CULVER'S JSP 23-37

PLAN REVIEW CENTER REPORT

Planning Review

Revised Preliminary Site Plan with Planned Development 2 Option, Special Land Use Request, and a Street Vacation Request

STORMWATE MANAGEMENT F

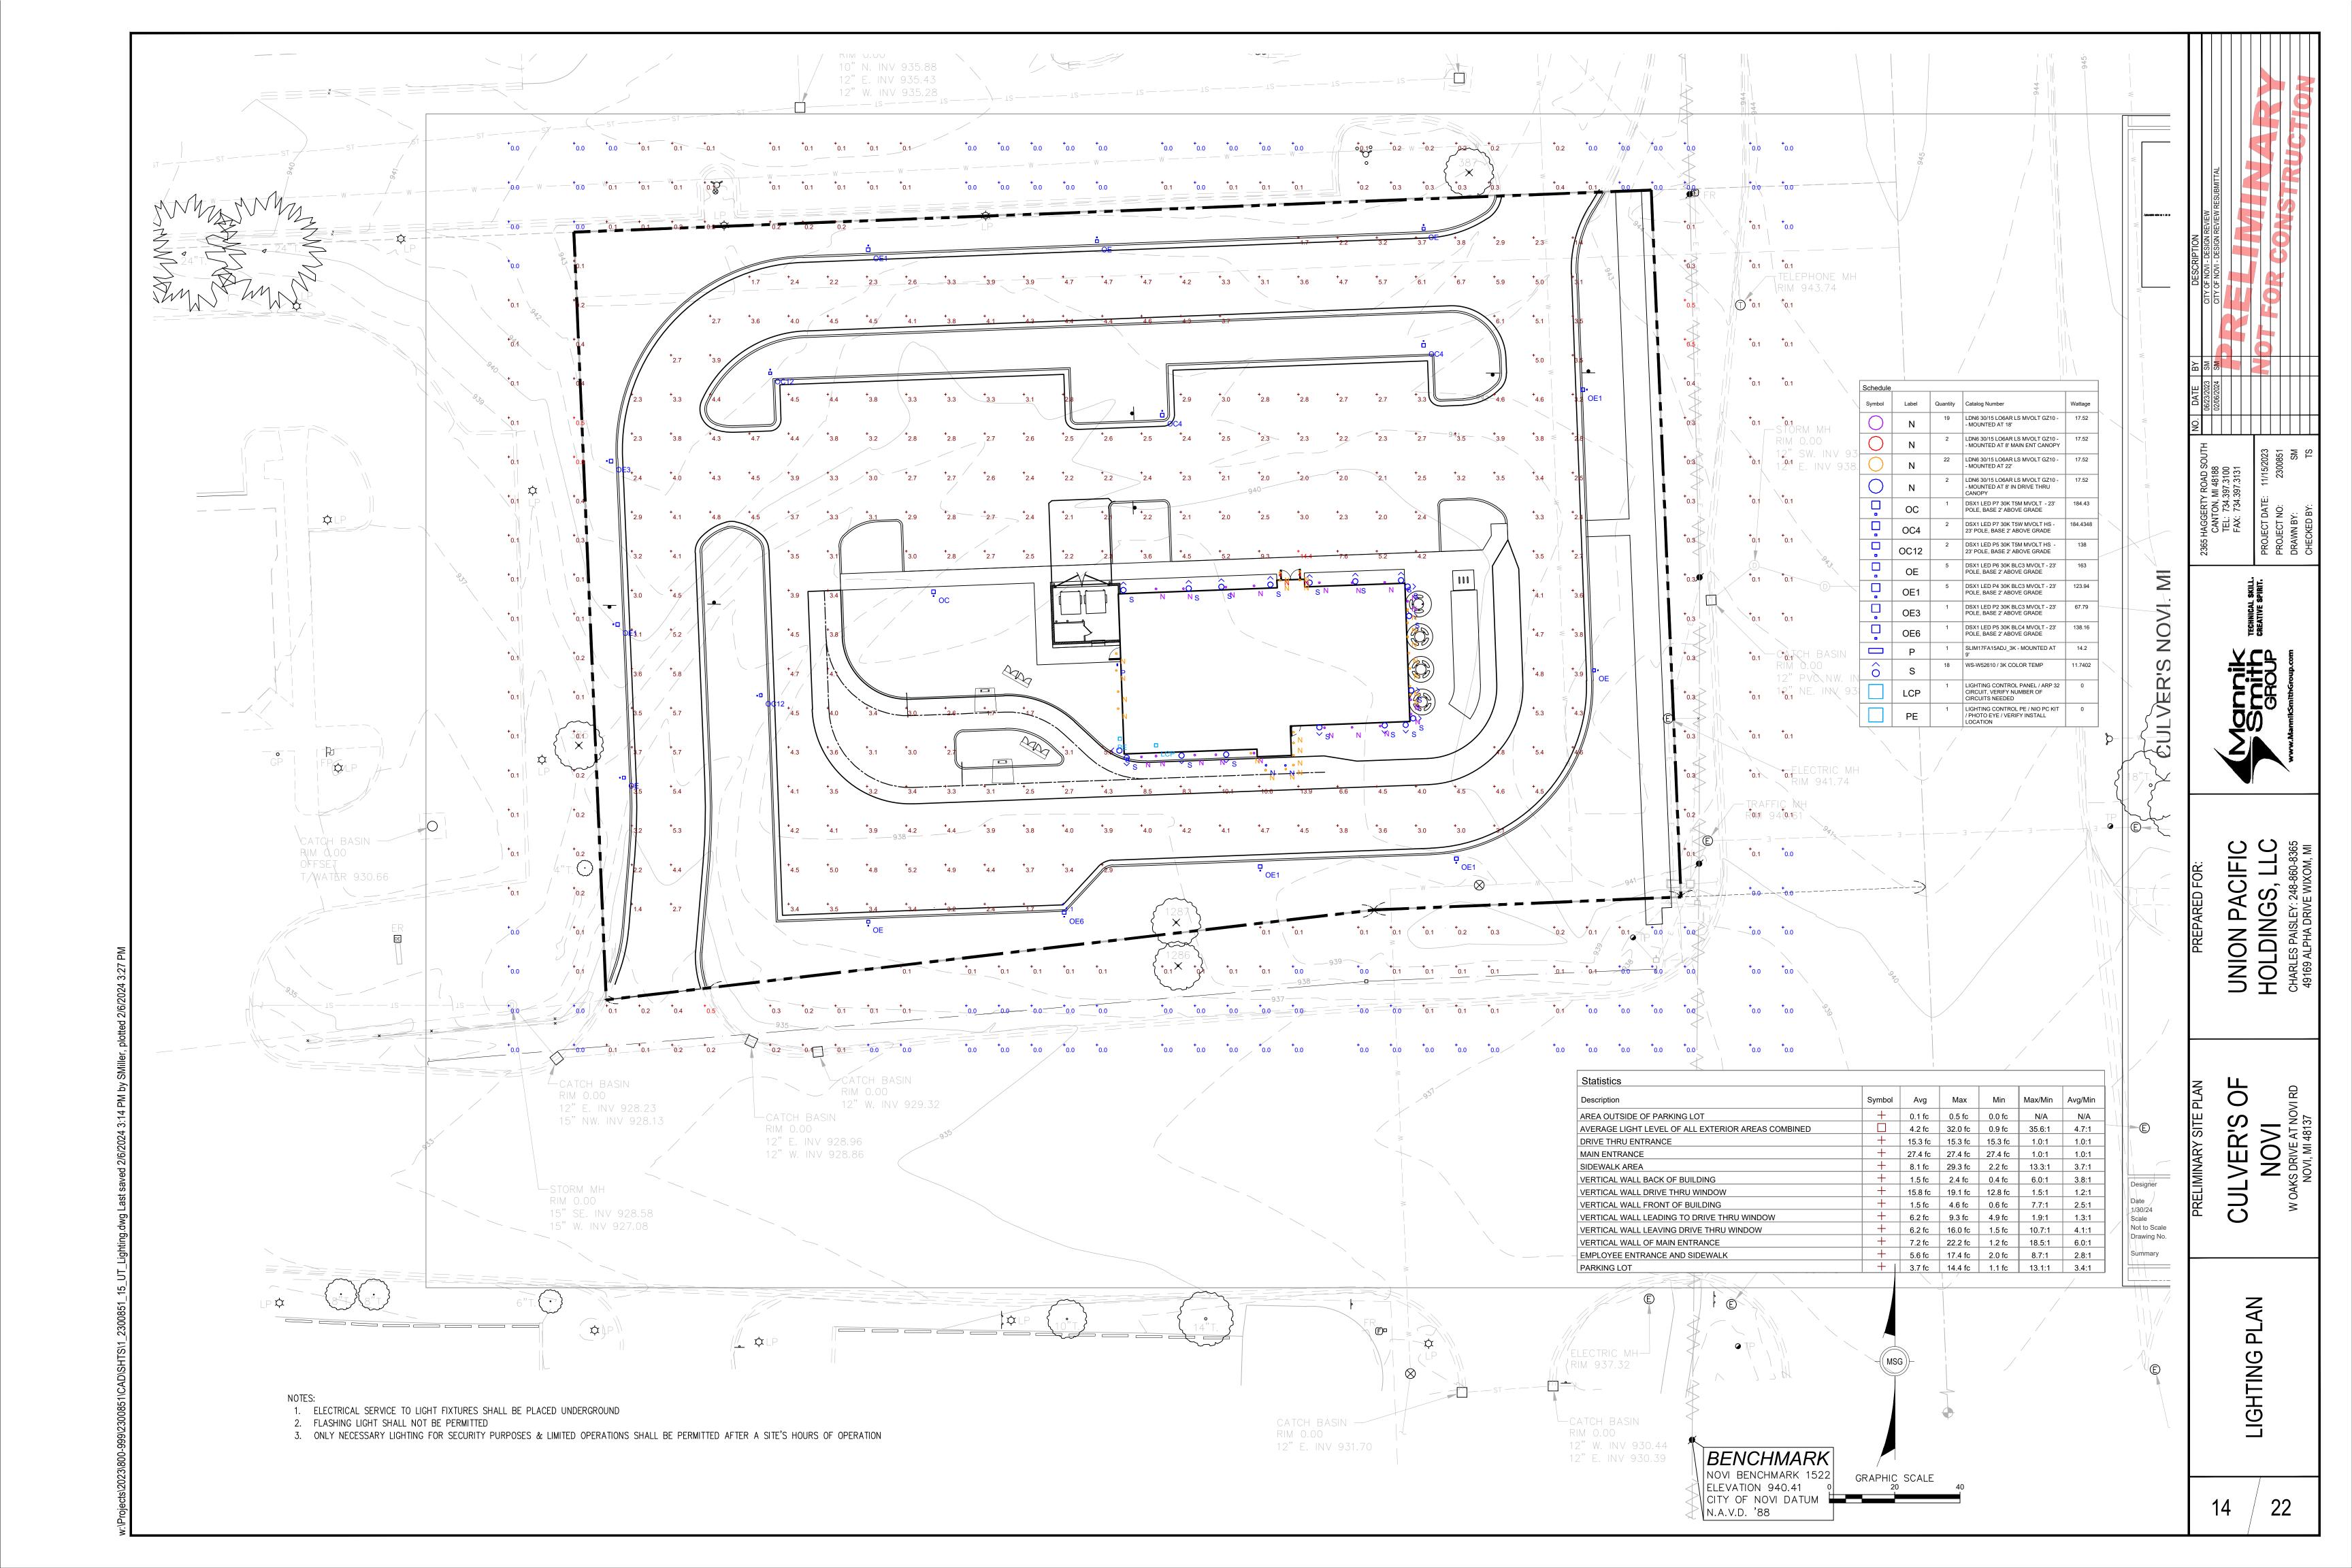
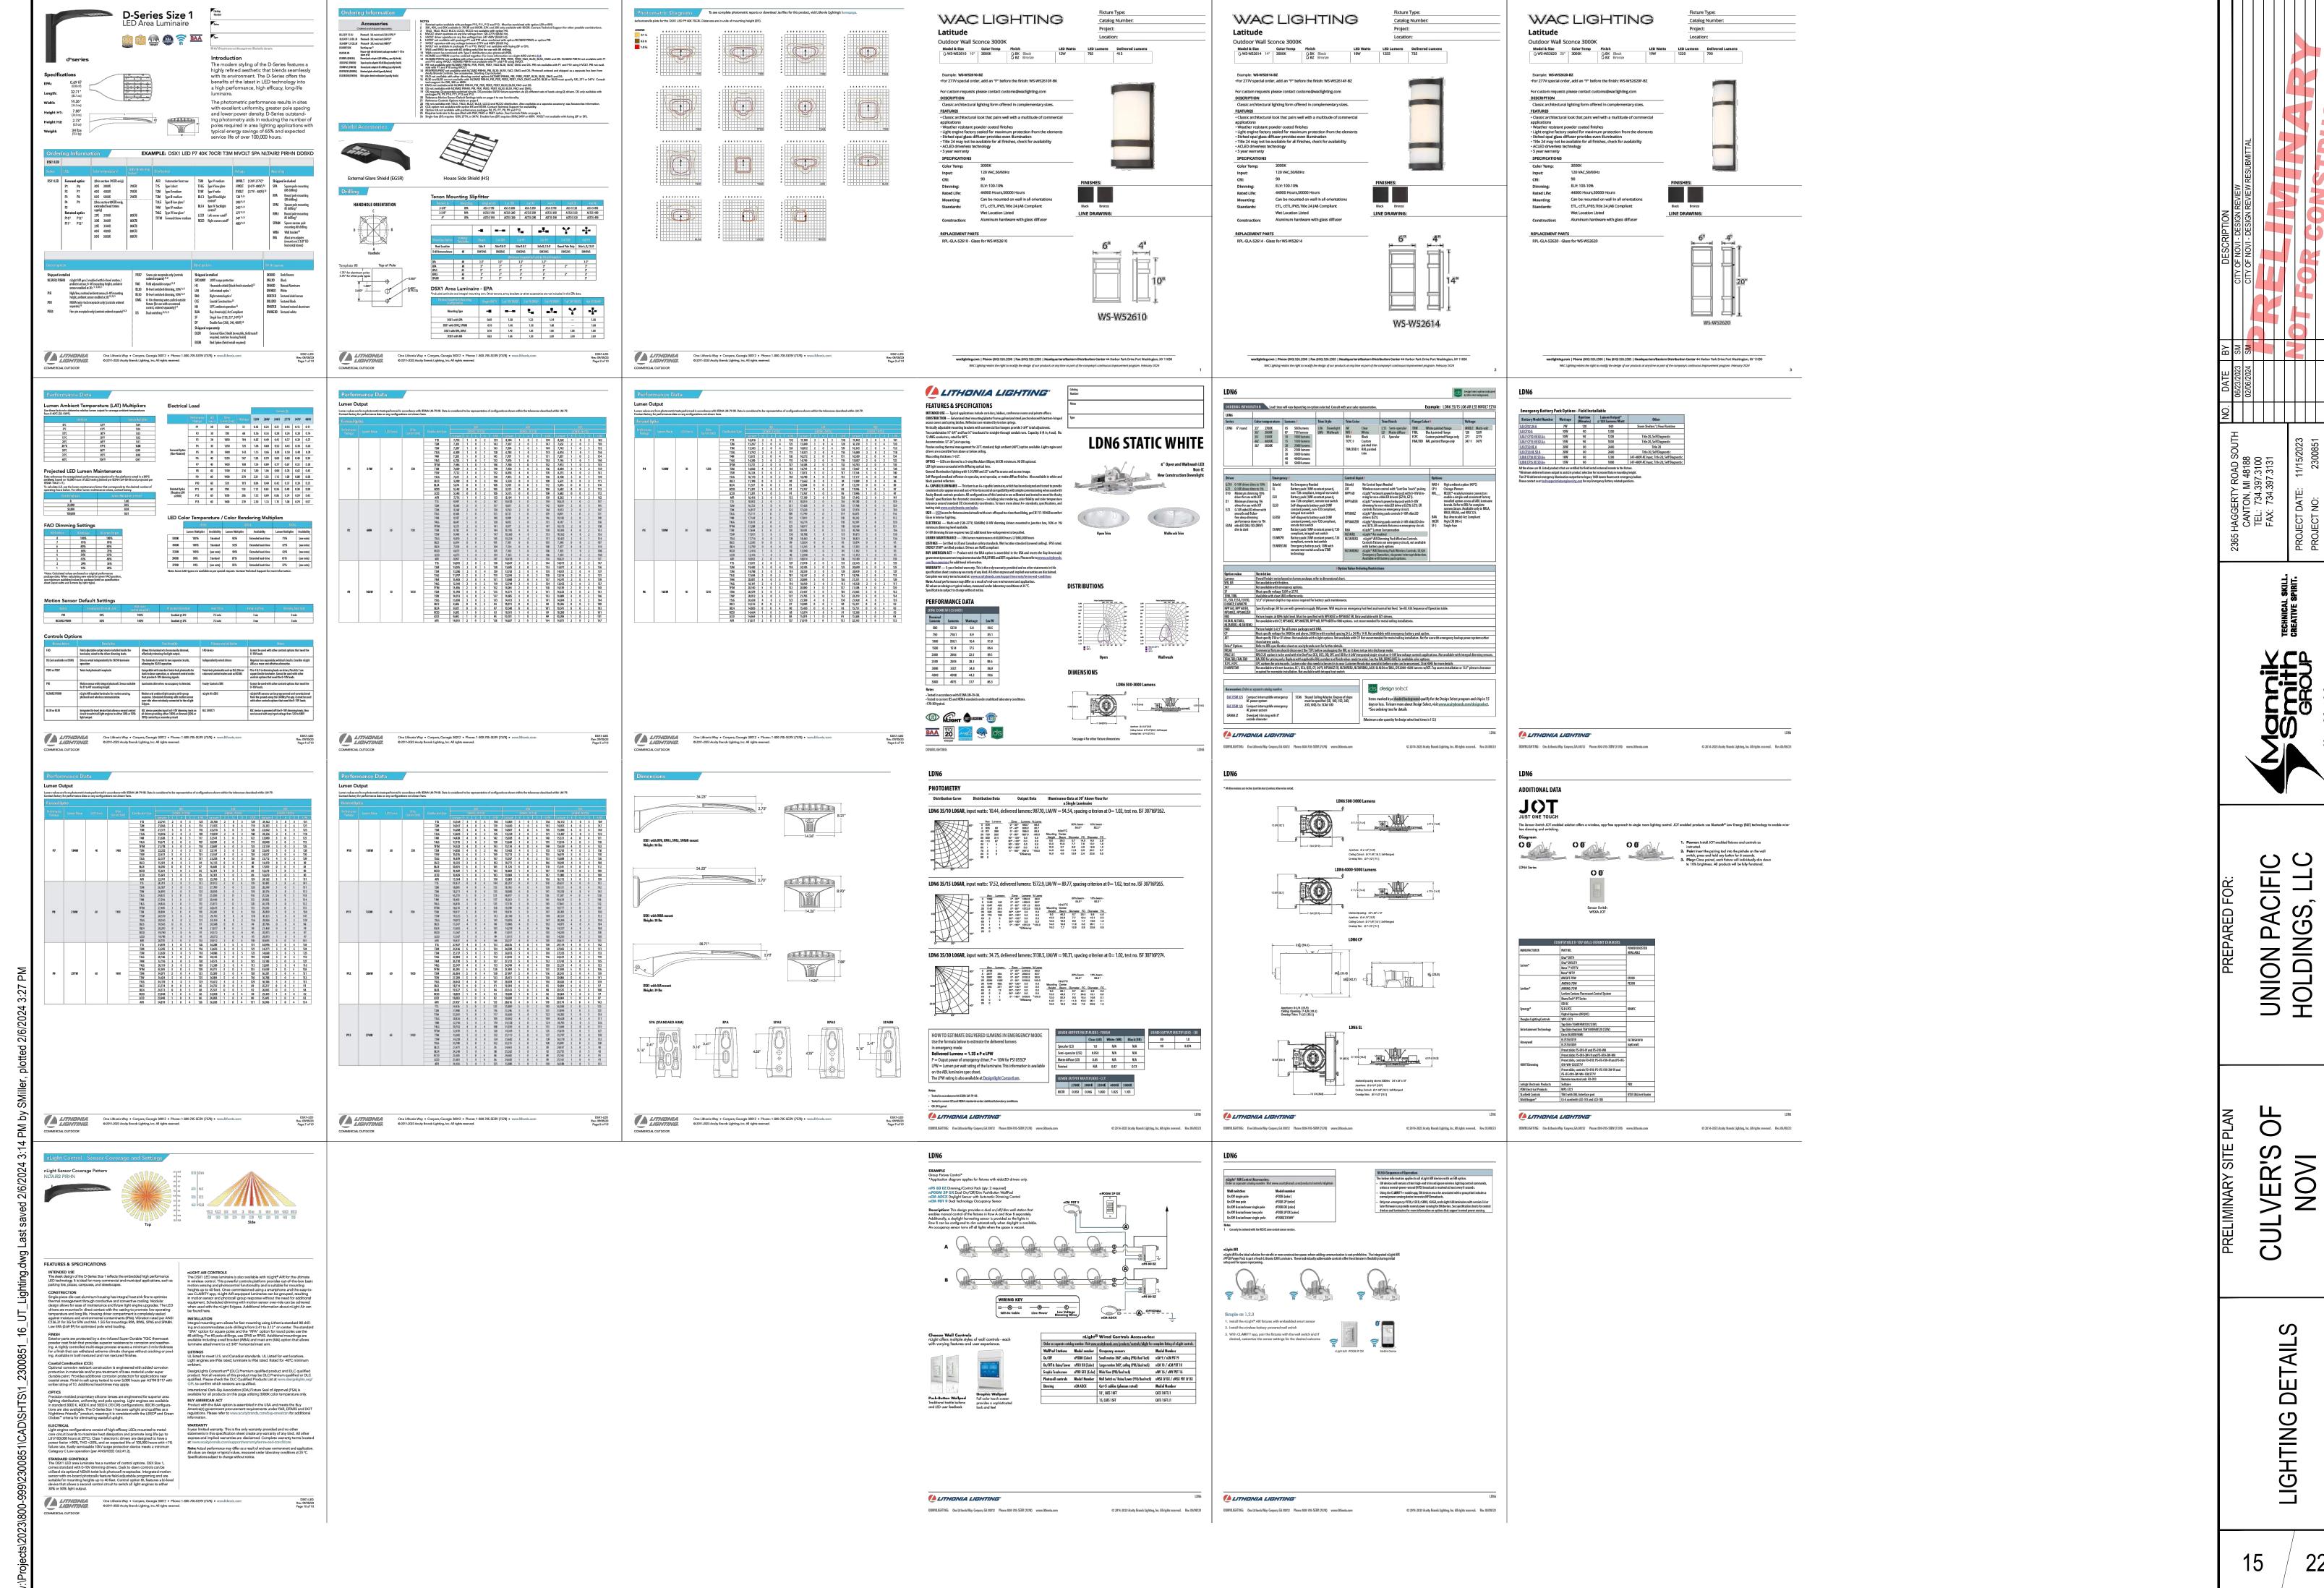
- 37. Remove underground detention details if underground detention is not proposed. (see sheet 12 & 13)
- 38. As part of the Storm Drainage Facility Maintenance Easement Agreement, provide an access easement for maintenance over the pretreatment structure.
